640 Lampson Street – Front Doors Path Access Variance

January 20, 2026

WHY ARE WE HERE?

FRONT DOOR ACCESS REVIEW

640 Lampson DP000240 Initial Comments

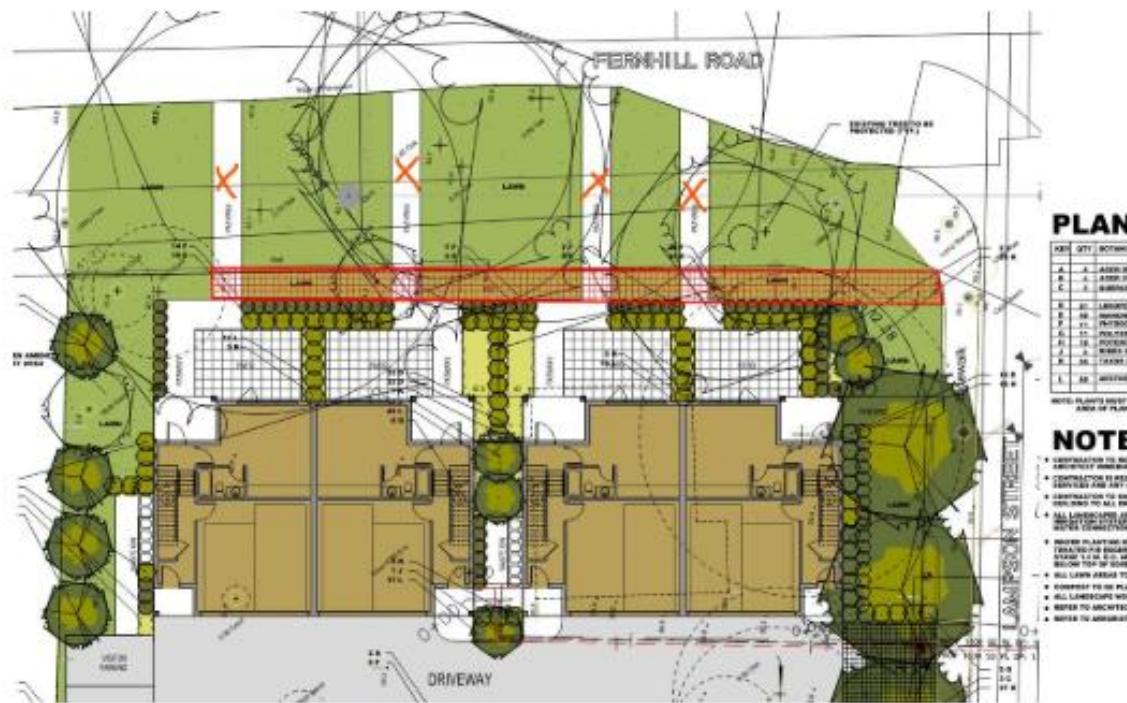
2. Staff has been considering 6m x 6m to be a standard minimum useable open space. The open space in the side yard on the west side of the property has a width between 4.5m and 4.75m. Please consider trying to expand this space to 6m in width.

3. Ideally the east building should be designed to address both frontages.
4. The gap between the two buildings is awkwardly narrow when considering the bins narrow the space to a 1m gap on the architectural drawing.

5. The landscape plan is different from the architectural in the building gap, with the bins on the one side and planters on the other. Please ensure that the landscape and architectural drawings are consistent.

6. This space is not ideal from a CPTED perspective. Between the bins/planters and the trees the sight lines are poor, there is limited defensible space, no indication of lighting in that space and there are limited eyes on that space from either building due to the sharp angle from the 2nd/3rd storey windows.

7. The windows on the interior elevations of the buildings are directly aligned, limiting privacy for each residence. On the one hand, frosting the windows would improve privacy. On the other, they are the only overlook for the space between the buildings.

8. The two trees planned for the gap between the buildings will likely be cramped, difficult to maintain and receive limited light. Furthermore, they limit sight lines and create indefensible space for people using the bins.

9. The space between the buildings should offer a 'pleasant pedestrian pathway'. Suggest moving the trees and ensuring that there is no 1m gap between two sets of bins.

6 MONTHS INTO DESIGN
SECOND COMMENTS – FEB 10, 2025

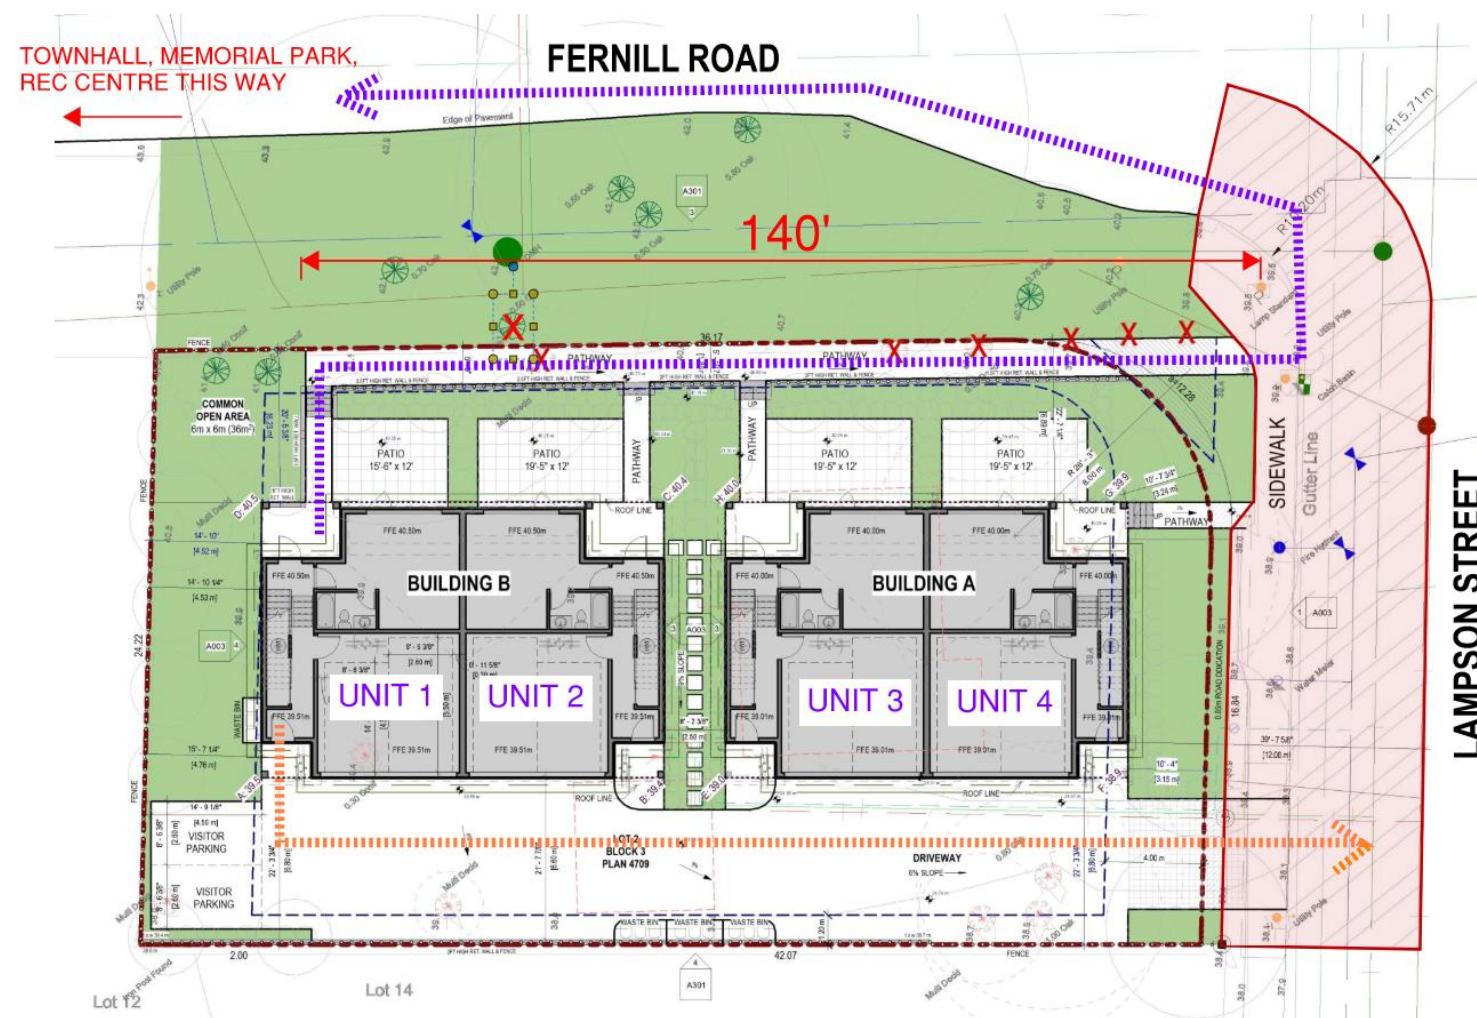
- 0.85m road dedication along Lampson is not shown.
- Storm water management, so the post construction flows do not exceed preconstruction flows, to be shown on servicing plan.
- Underground Hydro/Tel/Cable to the proposed development to be shown on servicing plan.
- Not supportive of the proposed pathways going through trees onto Fernhill Road.
- Access to units on north side should be as illustrated.

1. No sidewalk along Fernhill Rd, only on Lampson, therefore it is safer to connect to Lampson
2. Grade change is significant
3. Garry Oak roots health potentially compromised

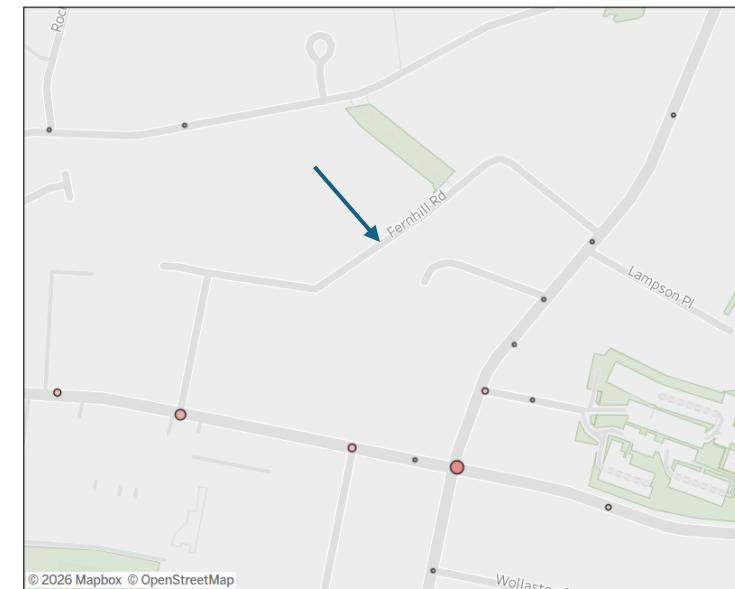
Requested internal pathway (in purple) would run directly through the spaces intended to be private outdoor areas for each unit. With driveway requested to be from Lampson at the rear of the units, and this pedestrian path in the front, private green space is essentially impossible to achieve for this development (on a 12,000sf lot that is not overbuilt this should not be the case.)

The pathway as requested by the Township results in the loss of 7 additional trees on site (marked with red X) than otherwise would happen. Pathways as proposed directly to Fernhill allow these 7 trees to remain.

From Arborist Report #2

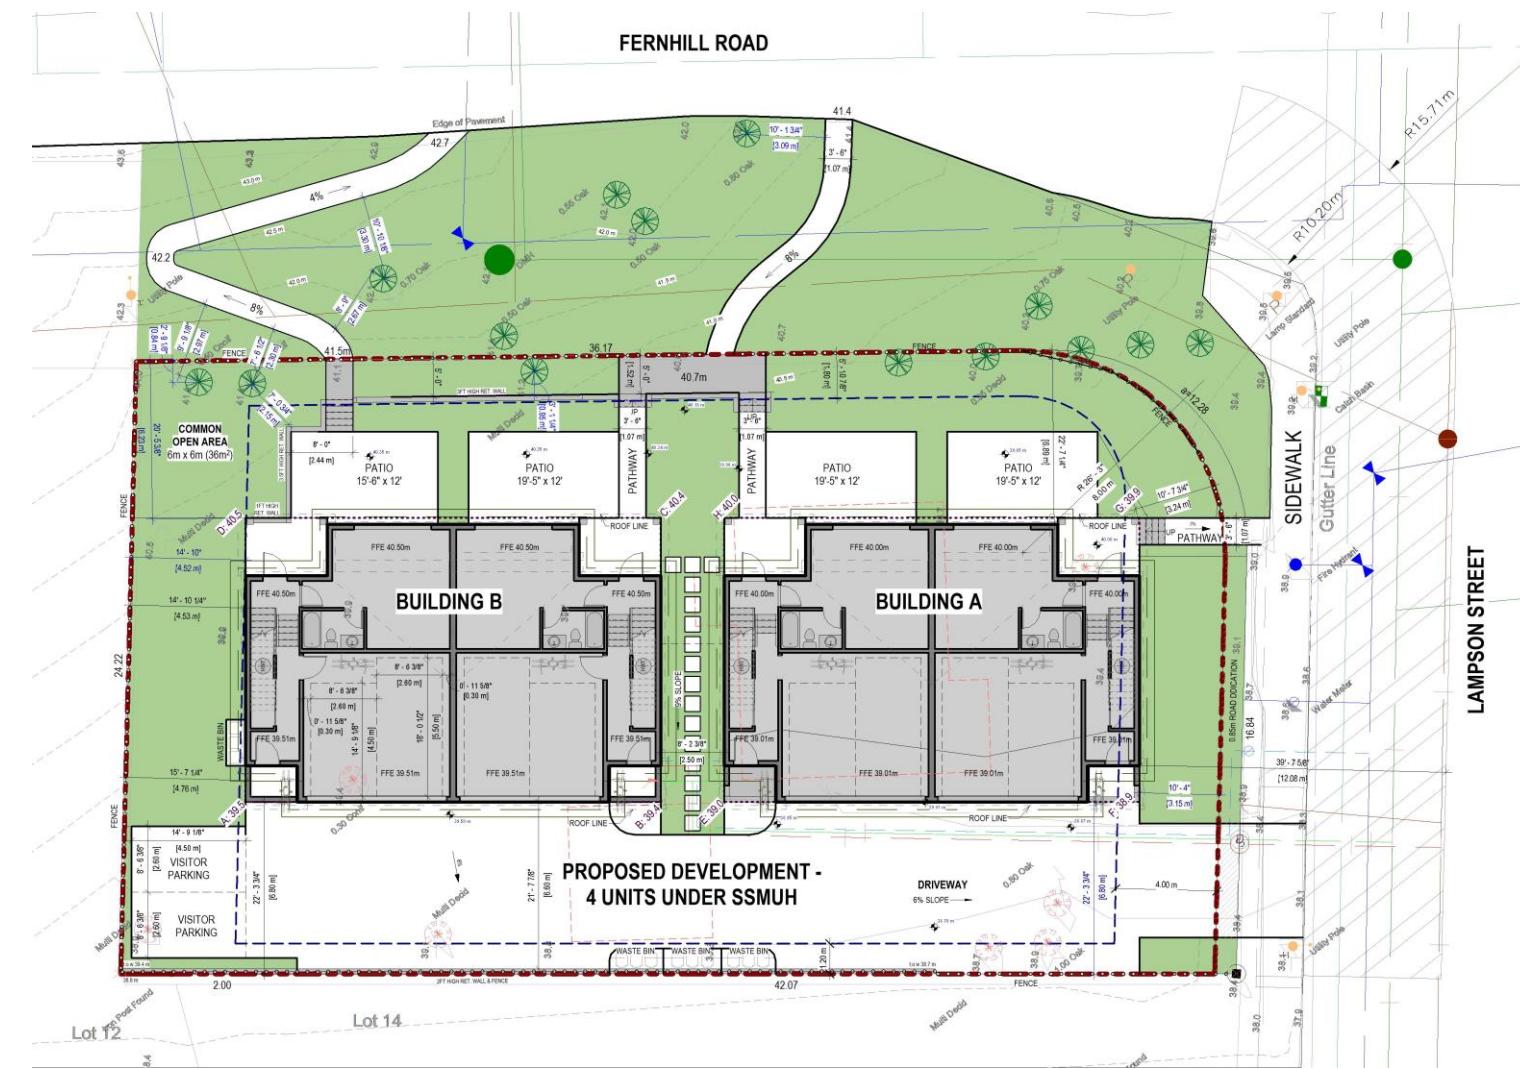
- The proposed change to allow two pathways to Fernhill Rd will greatly reduce impacts to retained trees 60, M8, and M4 (currently moderate to high impact) and allow the retention of trees 61, 62, 51, M3, M2 and M1 which were previously marked for removal under the originally approved pathway. *Please note that tree #51 will likely require removal regardless of design due to its condition.

- Installing controlled, hardscaped pathways provides a clear, durable route for visitors and minimizes damage to surrounding Garry oak ecosystems. When access is denied, people often create informal “desire lines” that spread trampling across larger areas, compacting more soil, exposing roots, and reducing understory vegetation health. Research in North American urban forests has shown that well-designed formal trails significantly reduce the extent of soil compaction, vegetation loss, and tree damage compared to unmanaged foot traffic. Concentrating use on defined paths therefore protects the critical root zones of Garry oaks while still allowing for safe and predictable public access. Please see ‘Appendix A’ for referenced materials and research links.
